REPORT TO	Statutory Planning Committee		
Meeting date	23 September 2026	File number	SD-030-24 20-6205-3
Title	Part 11B Development Application – Mixed Use Development at Lot 572 (No. 200) West Coast Highway, Scarborough – Determination and Development Application – Works within Planning Control Area abutting Lot 572 (No. 200) West Coast Highway, Scarborough – Determination		
Purpose	For decision		
Head of power	Part 11B of the Planning and Development Act 2005 116(1)(b) of the Planning and Development Act 2005		
Delegation	Instrument of Delegation 2024/02 Power of Committees, 2.8 and 2.5		
Confidentiality	Non-confidential		
Responsible officer	Seth Cohen-Radosevich – Planning Manager, Significant Development Assessment Unit Dale Sanderson – Planning Director, Land Use Planning Metro Central	Responsible Officer Conflict of Interest: Nil	
Date DPLH received / conformed	19 January 2026		
Processing days	132 days with agreed extension (Part 11B) 14 days (PCA DA)

Part 11B Development Application – Mixed Use Development at Lot 572 (No. 200) West Coast Highway, Scarborough – Determination and Development Application – Works within Planning Control Area abutting Lot 572 (No. 200) West Coa

Figure 1: City's markup of aerial photography demonstrating constructed and approved building heights of developments adjacent to the subject site.

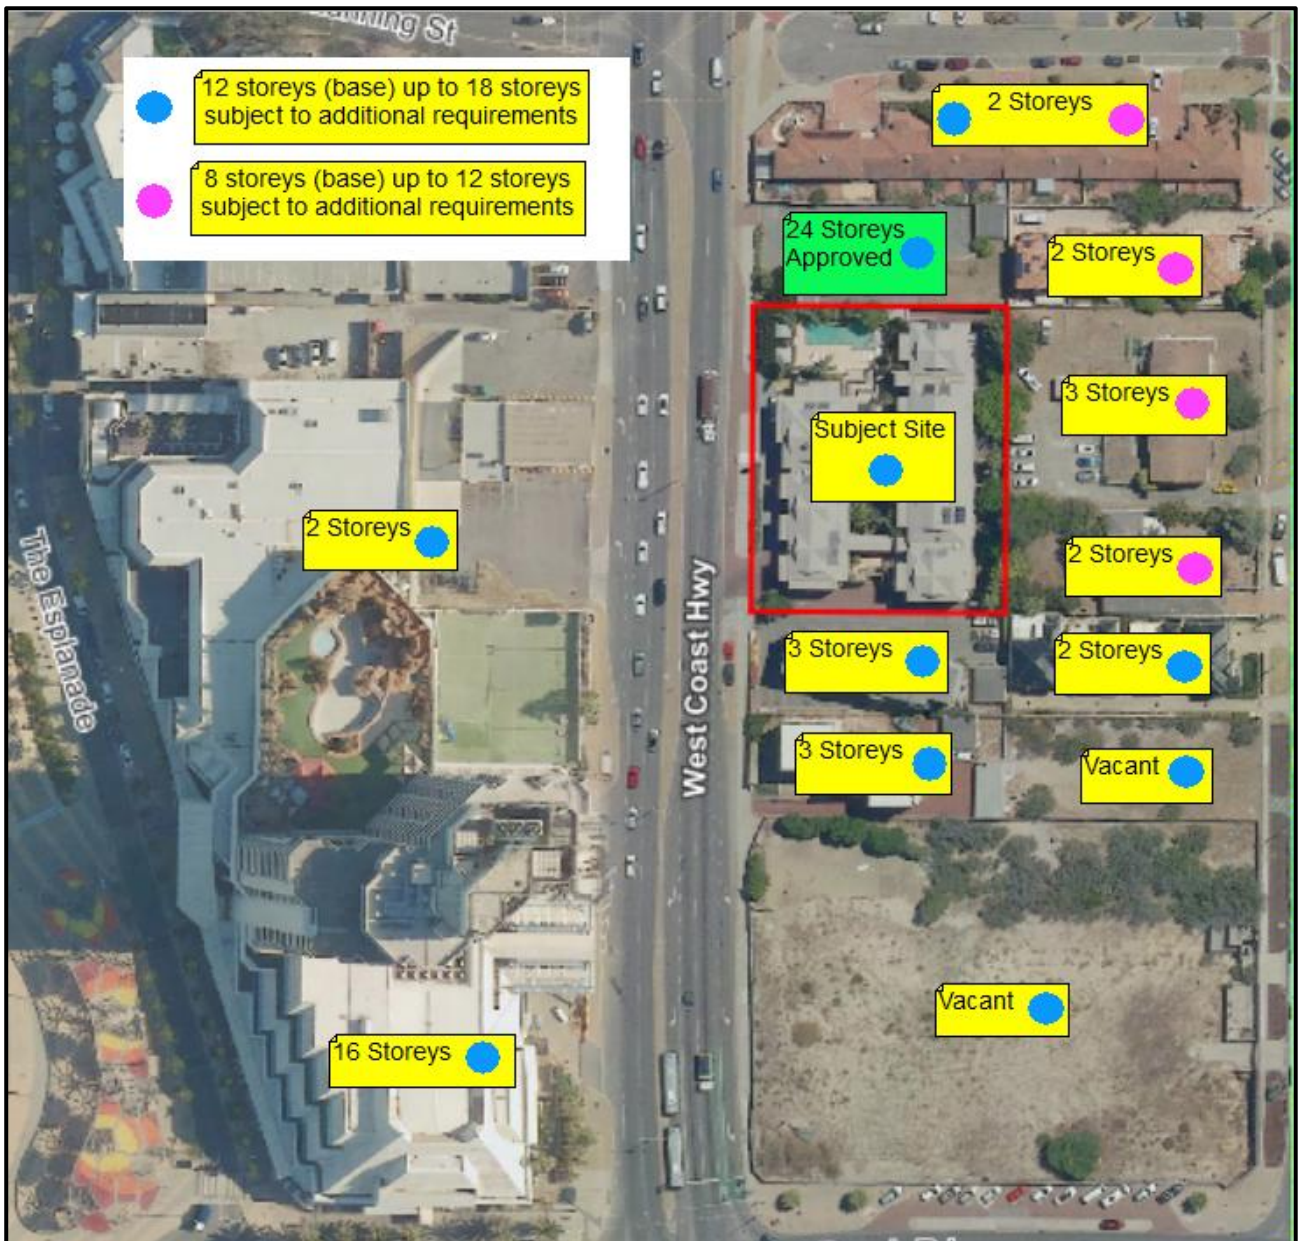
The City has undertaken a streetscape analysis to determine if the proposed building heights are consistent with the scale of the established and future built form context. This analysis as shown in Figure 1 below, demonstrates that the existing context of the locality is primarily low density, two to three-storey residential developments. The site is adjacent to the Rendezvous hotel, which at 16 storeys in height and less than the 'bonus height' maximum height of 18 storeys as permitted under the Scarborough DG. Sites directly adjoining are permitted to have a height ranging from 12 to 18 storeys, inclusive of the height bonus which would establish the expected future context.

community engagement and therefore building height at this scale would be contrary to the vision and the community's expectation for the locality.

Proposed Mixed Use Development – Lot 572 (No. 200) West Coast Highway, Scarborough
Proponent Response to City of Stirling Comments

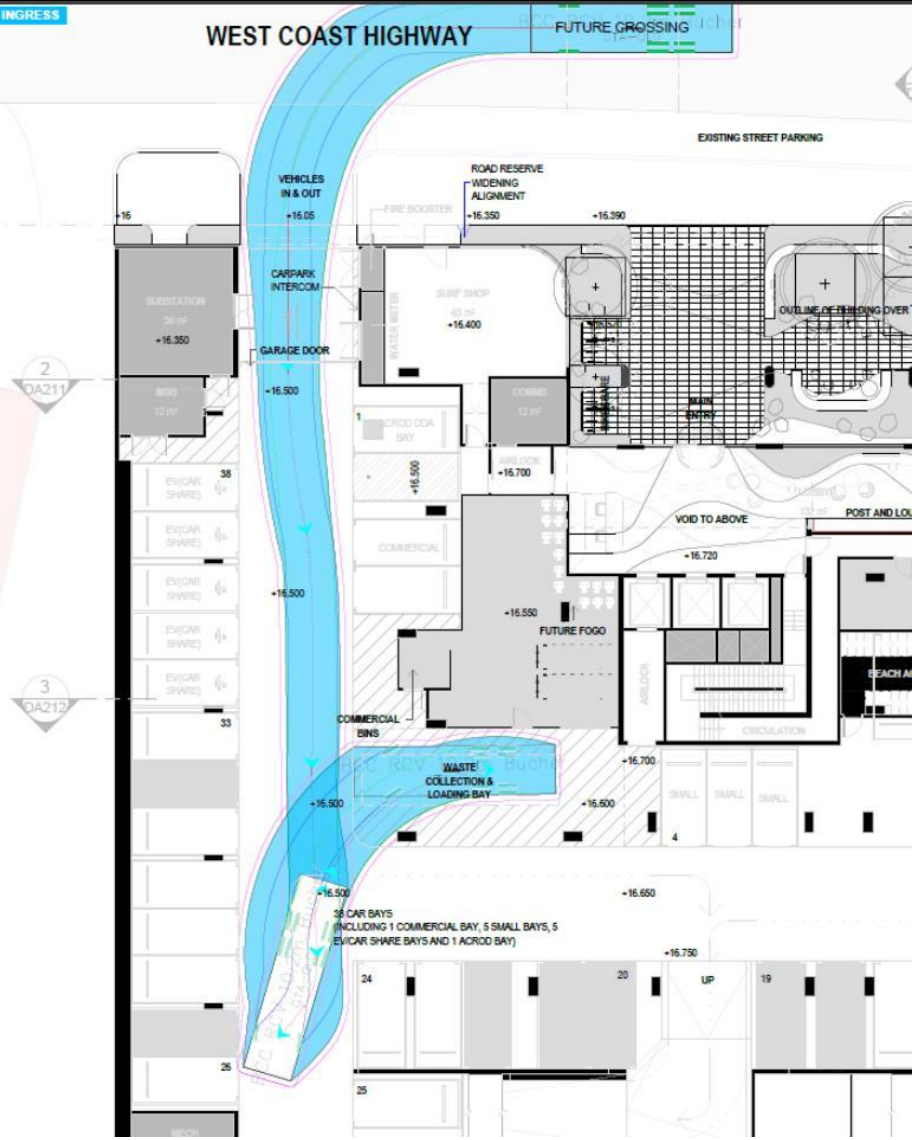
No.	Comment	Comment
	- The development has a nil street setback to the future lot boundary where the driveway meets the street. This does not provide any visibility for vehicles and pedestrians to see each other and is a traffic safety risk. As per Australian Standards AS2890.1, a 2.5m x 2m sightline truncation is required, aligned to the road widening boundary. - The development shows waste pickup internally from a dedicated “Waste Collection & Loading Bay”, with the Transport Impact Assessment showing turning movements for a 10m truck to access this bay, however, there is only a 4m ceiling height for the ground floor, which will accommodate a head height of approximately 3.5m once services are provided, which would be insufficient clearance to accommodate 10m waste and delivery truck vehicles. The ground floor parking area must provide a minimum head height of 4.5m in compliance with Australian Standard AS 2890, clear of any obstructions, to accommodate the waste truck and bin pickup requirements as well as standard delivery vehicle trucks. The 4.5m head height clearance also applies to the entry opening and internal garage door to allow the trucks to enter the development. This will require modifications to the built form which will impact the overall development. As such, the waste servicing and delivery arrangements as proposed will not be functional. - The turning movements in the Transport Impact Assessment demonstrates a 10m truck occupying both traffic lanes in West Coast Highway to access the proposed crossover. This will restrict traffic movements along West Coast Highway. West Coast Highway is a 60km/hr Primary Distributor Road carrying almost 40,000 vehicles per day, straddling lanes is unlikely to be supported by MRWA and would present a safety issue for motorists. - The site access needs to be modified to ensure that the 10m truck can turn into the site without impacting traffic occupying the median traffic lane. - Additionally, the column opposite bay 24 blocks manoeuvring for the Waste Collection & Loading Bay, as demonstrated by Diagram 4 of the Waste Management Plan. - The fire booster needs to be relocated or amended to be wholly within the property boundary and so that the door does not open over the road widening boundary.	development will not be accommodating large heavy rigid delivery vehicles, as would be typical for larger commercial developments, such as supermarkets, where loading docks are provided. Rather, the development incorporates two small scale commercial tenancies which can be serviced by smaller commercial vehicles (which typically fit within 3.5m height clearance). An amended Transport Impact Assessment has been provided which addresses access requirements for the delivery vehicle and confirms that a 3.5m headroom clearance is required (not 4.5m as suggested). The TIA has been amended to adjust the vehicle manoeuvring, ensuring that the waste vehicle does not conflict with the column opposite bay 24. We note that MRWA have no provided any objection to the proposed development. Refer to Attachment 1 – Amended Development Plans and Attachment 6 – Amended Transport Impact Assessment.

No.	Comment	Comment
	 Amended plans and additional information will be required to address the abovementioned matters.	
3	Parking and Sustainability The following Parks and Sustainability comments are provided: • All the trees on the ground floor within true deep soil area are small trees. Conversely, the large trees are proposed built on structure at level 4, within a 1m deep planter. 1m depth is not sufficient for large trees, as it does not provide them with sufficient depth to establish safely or for the long term, particularly in a windy coastal environment. • There is an opportunity to locate the large and medium trees at ground level instead, which will also provide shade to the streetscape. • The Scarborough DG does not provide requirements for deep soil area per tree, however using <i>Residential Design Codes Volume 2 – Apartments</i> as a guideline, a small tree requires 9m² deep soil area, a medium tree requires 36m² and a large tree requires 64m². The deep soil areas are	An Amended Landscape Concept Report has been prepared which addresses the following: - The indicative planter depth is shown as being a minimum of 1m deep and is not intended to represent a maximum depth. Additional depth can be addressed through the submission of a detailed landscaping plan required as a condition of development approval. - There is insufficient space to include a large tree on the ground floor, and if provided, it would undermine the ability to provide also provide smaller trees. Notwithstanding, the Landscape Concept Report has been amended to include one (1) medium tree and six (6) small trees in lieu of six (6) small trees as was originally proposed. - Tree sizes and species selections have been adjusted to appropriately reflect the required deep soil area requirements and coastal environment. Should further changes be required, there is an opportunity to refine species selection as part of the detailed landscaping plan required as a condition of development approval. - The proposed <i>Melaleuca leucadendra</i> has been amended in the amended Landscape Concept Report. Refer to Attachment 3 – Amended Landscape Concept Report.
